CITY OF VANCOUVER
POLICY REPORT
DEVELOPMENT AND BUILDING

TO: Vancouver City Council
FROM: Director of Planning
SUBJECT: CD-1 Rezoning - 5718 Willow Street (King David High School)

King David High School Addition

Basement Floor Plan

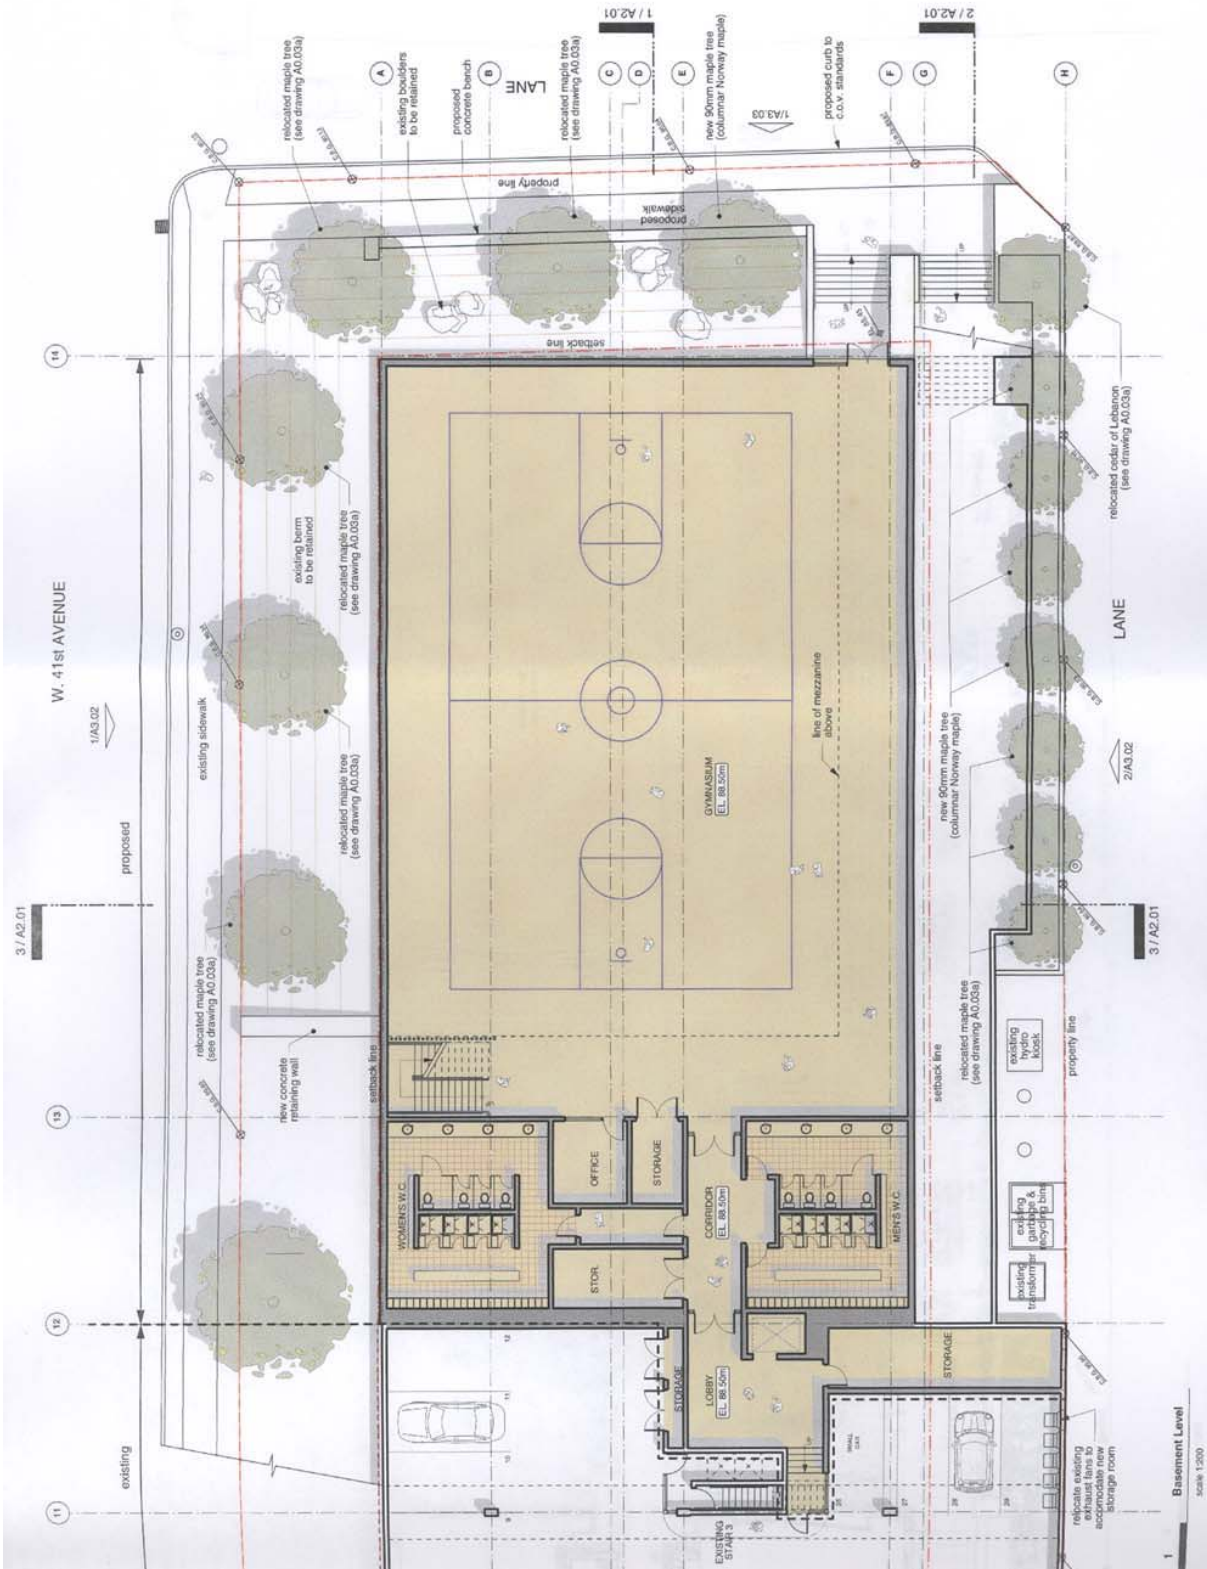
Note to Applicant: Provide for enhanced accessibility from the underground parking structure directly to the gymnasium. All terrace areas on the grounds should provide for enhanced accessibility.

Building Sections - Addition

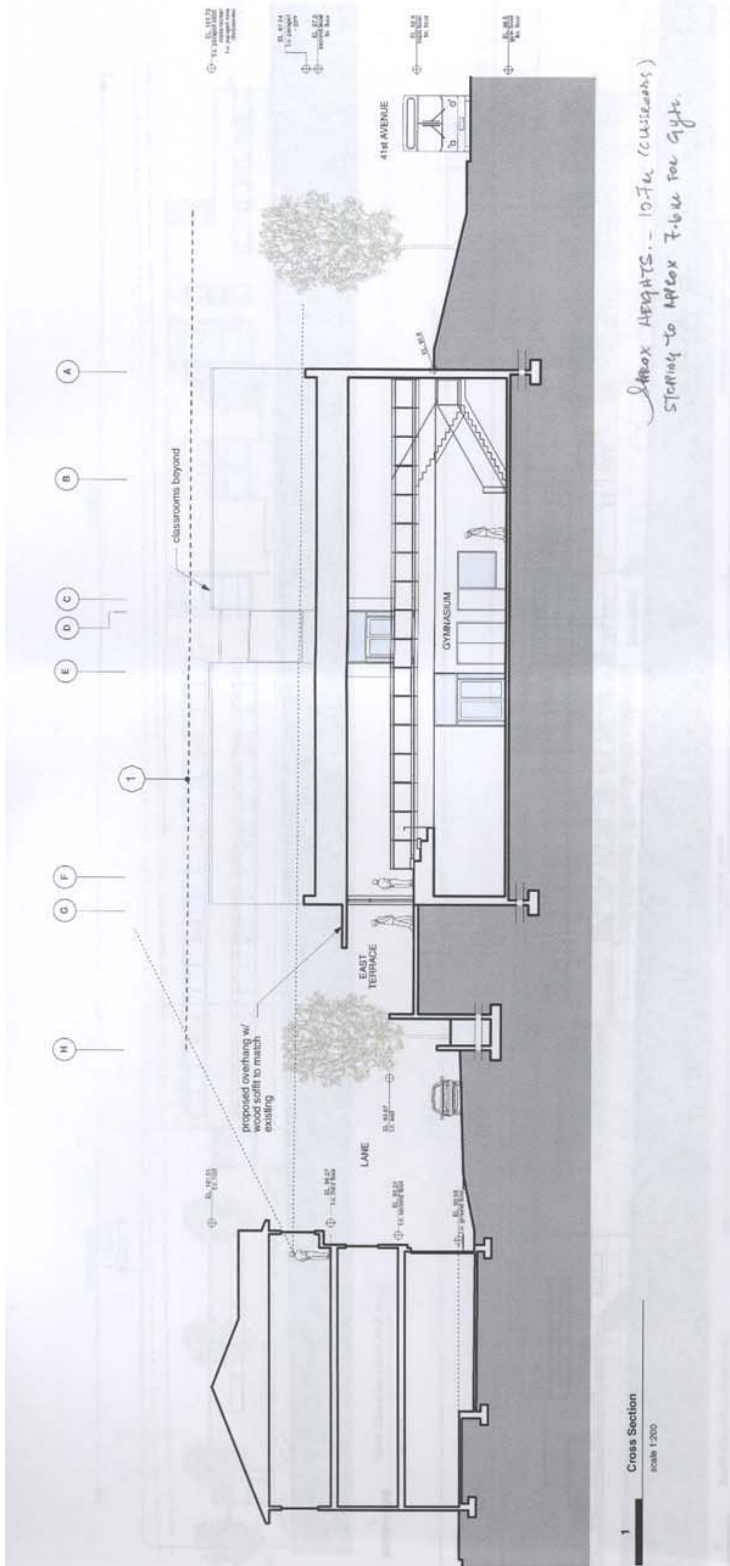
- The terrace area accessed from the mezzanine level of the gymnasium is a potential noise source and should be either relocated to the north street elevation, or removed. An acoustic report is requested to evaluate acoustic levels generated by related assembly uses and recommendations for sound attenuation.

- Consider a green treatment for the gymnasium roof, with additional terrace landscaping along the lane edge to further buffer and transition scale. Large windows on the gymnasium's south lane elevation should be either significantly reduced in size or relocated to the north street elevation, to limit direct overlook to the neighbouring townhouses and reduce glare from the southern exposure.
